250622 - HomeCo Roselands Mall - Council RFI 2 (August 2026) - Acoustic Responses - R0

TO: Jacob Barsoum **DATE:** 19 August 2026
COMPANY: HMC Capital
EMAIL: Jacob.Barsoum@hmccapital.com.au
FROM: Matthew Furlong
SUBJECT: HomeCo Roselands Mall - Council RFI 2 (August 2026) - Acoustic Responses - R0

Pulse White Noise Acoustics Pty Ltd (PWNA) has been requested by HMC Capital to undertake a review and respond to the comments provided by SLR Consulting Australia (SLR) as part of the independent *Noise and Vibration Impact Assessment Peer Review (dated 18th August 2026)*.

**RE: HomeCo Roselands Shopping Centre Expansion, Roselands NSW
Noise and Vibration Impact Assessment Peer Review**

Figure 1 Source Location Map (Ref: Figure 7 of NVIA)

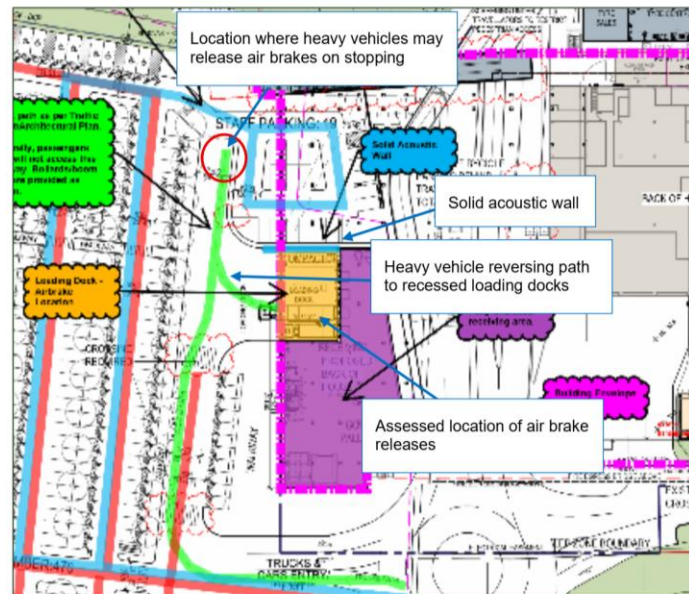
As shown in **Figure 1**, the development includes a recessed loading dock arrangement, and the indicated heavy vehicle route (green line) shows that heavy vehicles are required to reverse into the loading bays.

While the NVIA report states that the site has been designed to minimise reversing movements, the site plan and vehicle routes indicate that reversing manoeuvres are a part of normal operations. If reversing is required, reversing alarm noise would represent a relevant operational noise source that may also contribute to sleep disturbance impacts.

- Demonstrate that reversing movements are not required as part of normal site operations, or
- Update the assessment to consider operational noise and maximum noise (sleep disturbance) impacts from broadband reversing alarms.

The sleep disturbance assessment is based on air brake releases occurring at the loading dock area (shown in **Figure 1**, and Figure 7 of the NVIA).

Heavy vehicles may reasonably stop at alternative locations along the manoeuvring route prior to reversing into the recessed loading docks. **Figure 1** indicates that heavy vehicles access the loading docks by travelling past the loading area before reversing into the docks.

It is therefore plausible that air-brake releases may occur at the location where heavy vehicles initially stop prior to reversing into the assigned loading dock (shown in **Figure 1**). This location appears to be closer to receivers within NCA1 than the assessed air-brake location adopted in the NVIA. Higher maximum noise levels than those presented in the assessment may occur if air-brake releases take place at this alternative location.

- Demonstrate that the adopted airbrake source location represents a reasonable worst-case scenario, or
- Update the sleep disturbance assessment to consider the impacts from the location along the heavy vehicle route, closer to NCA1.

- In the first instance, SLR are correct. For the noise modelling, we did not assume a reversing alarm.
- In the updated acoustic assessment (revision 3) we have included the noise modelling of reversing alarm as recommended by SLR.
- In accordance with the SLR comments, a worst-case scenario assumption of a reversing alarm at the end of the truck pathway (assuming then reversing into the loading dock) has been modelled. This is indicated in the figure below.

- Section 2.4.2 and 2.4.3 of the SLR are discussing the same item, as such we will address both items collectively.
- In response to item **2.4.3** first, we note:

- SLR suggestion that airbrakes will need to occur when changing directions (forward to reverse) is incorrect.
 - We do agree with SLR that once the truck is parked within the loading dock, an airbrake will occur. This is currently modelled in the acoustic assessment.

- Therefore, to address comment **2.4.1**, simply an airbrake release will not occur closer to the NCA1 as airbrakes do not need to occur when changing direction as assumed/suggested by SLR.

- As such, the PWNA assumed location of Airbrake during the night period is still valid and representative of the acoustic impacts to occur onsite.
- To address this concern, the Plan of Management (PoM) can be updated to prevent truck airbrakes been used during the night (10:00pm and 7:00am) from occurring outside the loading dock. Additionally, signage can be provided which reminds trucks to prevent air-brake usage outside the loading dock area.

Figure 1 Source Location Map (Ref: Figure 7 of NVIA)

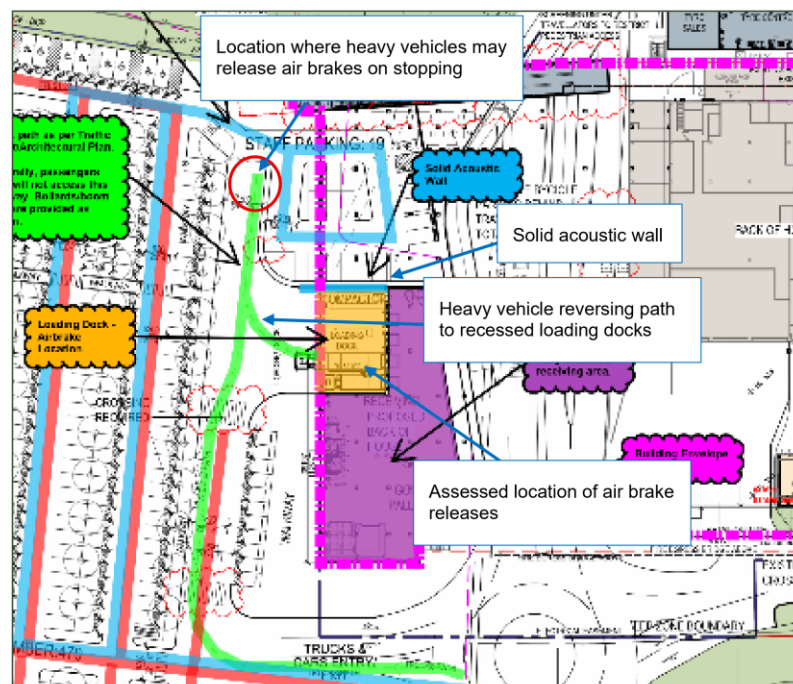
As shown in **Figure 1**, the development includes a recessed loading dock arrangement, and the indicated heavy vehicle route (green line) shows that heavy vehicles are required to reverse into the loading bays.

While the NVIA report states that the site has been designed to minimise reversing movements, the site plan and vehicle routes indicate that reversing manoeuvres are a part of normal operations. If reversing is required, reversing alarm noise would represent a relevant operational noise source that may also contribute to sleep disturbance impacts.

- Demonstrate that reversing movements are not required as part of normal site operations, or
- Update the assessment to consider operational noise and maximum noise (sleep disturbance) impacts from broadband reversing alarms.

The sleep disturbance assessment is based on air brake releases occurring at the loading dock area (shown in **Figure 1**, and Figure 7 of the NVIA).

Heavy vehicles may reasonably stop at alternative locations along the manoeuvring route prior to reversing into the recessed loading docks. **Figure 1** indicates that heavy vehicles access the loading docks by travelling past the loading area before reversing into the docks.

It is therefore plausible that air-brake releases may occur at the location where heavy vehicles initially stop prior to reversing into the assigned loading dock (shown in **Figure 1**). This location appears to be closer to receivers within NCA1 than the assessed air-brake location adopted in the NVIA. Higher maximum noise levels than those presented in the assessment may occur if air-brake releases take place at this alternative location.
